APPEAL SUMMARY

Appeal ID: 22238	Project Address: 1120 SE Morrison St
Hearing Date: 12/18/19	Appellant Name: Patrick Turina
Case No.: B-008	Appellant Phone: 5038472185
Appeal Type: Building	Plans Examiner/Inspector: Maureen McCafferty
Project Type: commercial	Stories: 7 Occupancy: A-3, B, R-2, S-1, S-2 Construction Type: I-A, III-A
Building/Business Name: Modera Morrison	Fire Sprinklers: Yes - Throughout
Appeal Involves: Erection of a new structure, other: Additional information for appeal 22072, item 1	LUR or Permit Application No.: 19-131007-EA
Plan Submitted Option: pdf [File 1] [File 2] [File 3] [File 4]	Proposed use: Multi-Family Residential and Retail

Modera Morrison White Paper Fire Analysis of FRT Wood Alternate

① EXTERIOR WOOD FRAME ASSEMBLIES
3" = 1'-0"

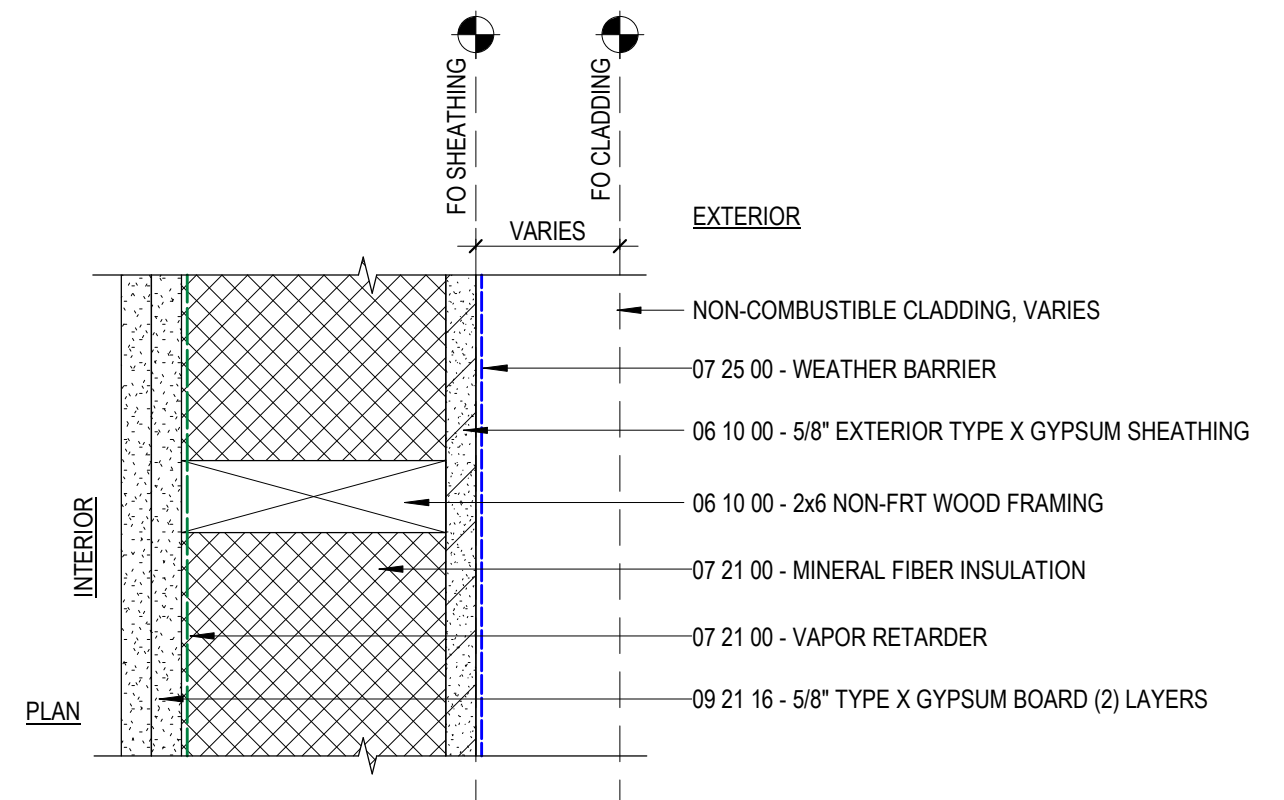
To offset these unmet Type III Code Guide conditions, the proposed design includes mineral wool insulation friction fit between wood studs to fill the entire 6" nominal wall cavity in lieu of fiberglass insulation. The mineral wool insulation contributes to an increased level of fire resistance of the wood-framed exterior walls. Please see attached exhibit 1C for proposed wall assemblies.

Reason for alternative Regarding Code Guide condition #4, the proposed wall assemblies do not require sacrificial studs to achieve a higher level of fire-resistance than required by code. A non-FRT wood framed assembly using mineral wool insulation without sacrificial studs outperforms an FRT wood framed assembly using fiberglass batt insulation and sacrificial studs. Please see attached white paper analysis for more information.

Use of non-fire resistant treated wood in exterior walls of Type III construction with mineral wool insulation: Granted as proposed.
